T-SB-0016-12

MIL "ON" P043E, P043F, P2401, P2402, & P2419 Due to Water Intrusion into Charcoal Canister

Service Category Engine/Hybrid System

Section Emission Control

Figure 1. Fuel Tank Filler Pipe Cover: PREVIOUS Design

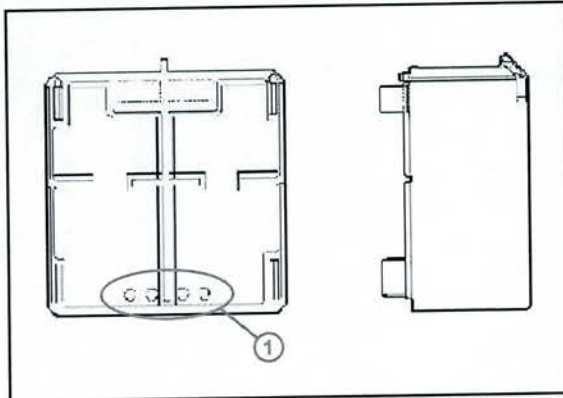
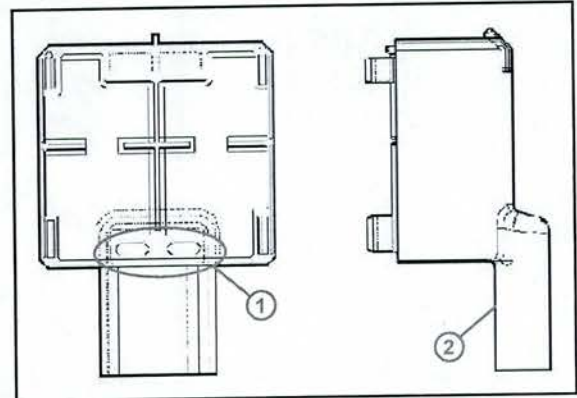
5. For 2007 Yaris, follow this procedure, all other model years proceed to step 7. Inspect the fuel tank filler pipe cover holder for the presence of the drain hole shield that is included with the updated fuel tank filler pipe cover holder as shown in Figures 1 and 2 below.

6. If drain hole shield is present, proceed to step 7.

If drain hole shield is NOT present, replace the fuel tank filler pipe cover and cover holder with the updated parts.

Figure 4.

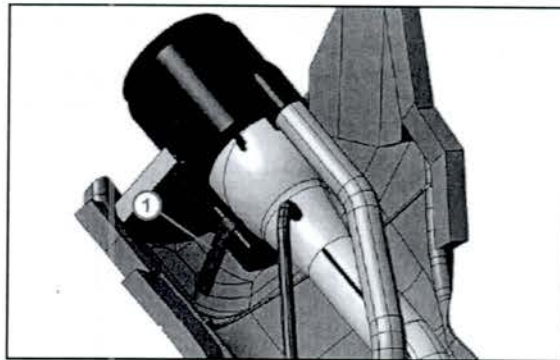
7. Replace fuel tank filler pipe protector with updated part. Slide the supplied plastic tie over the fuel tank filler pipe cover holder then reinstall original fasteners.

Do NOT adjust the length or tension of zip tie.
